February 18, 2021

We did discuss his formal comments and here are the key points that I would like to submit in response to his outreach.

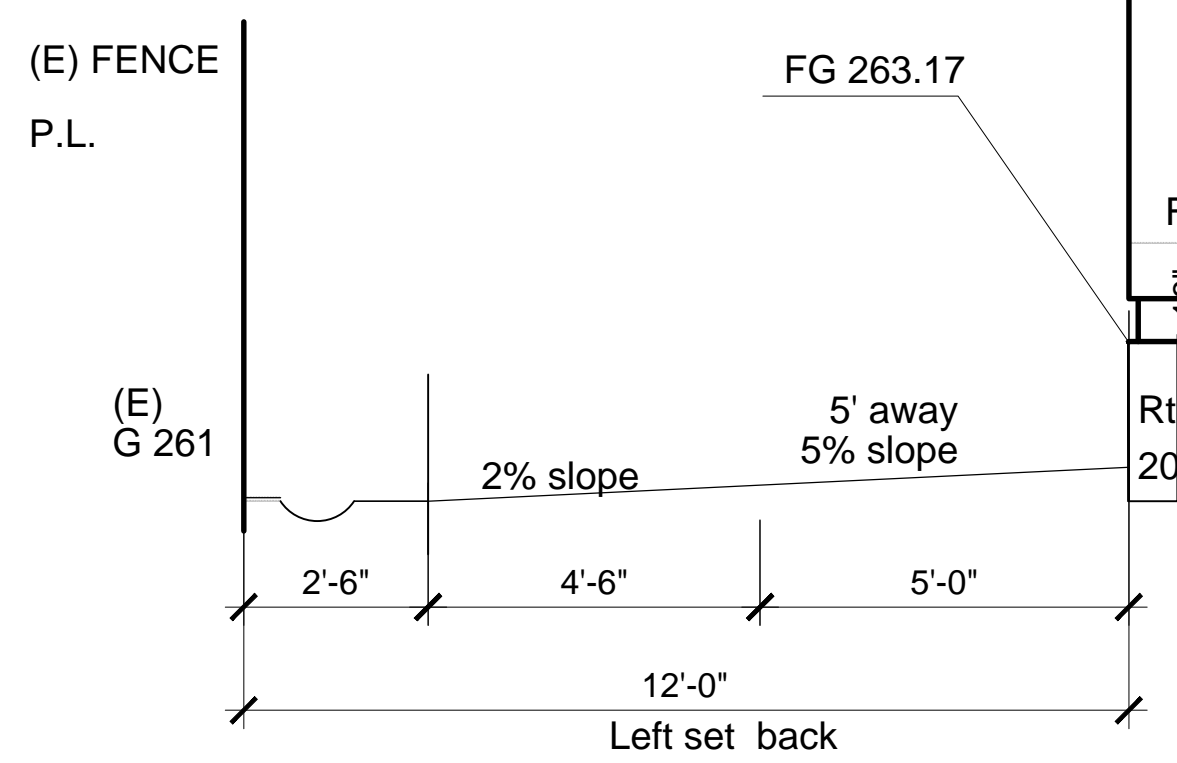
- a. We are aligned on putting opaque glass on the bathroom windows.
 - b. With the proposed reduction of the grade by 1 ft, the effective human eye level for the master bedroom windows will be lower than previous. Our design also complies with the Los Gatos design guidelines.

- i. Windows should be placed to minimize views into the living spaces and yard spaces near neighboring homes.
 - ii. When windows are needed and desired inside building walls, they should be modest in size and not directly opposite windows on adjacent homes.

- iii. We will add more screen trees before moving in, to provide a screen at least this level. See sheet A1 and A14.
 - c. Landscaping may be used to mitigate privacy concerns so long as the landscaping does not deny solar access to living spaces and actively used yard areas of neighboring homes. Our design also complies with the Los Gatos design guidelines.
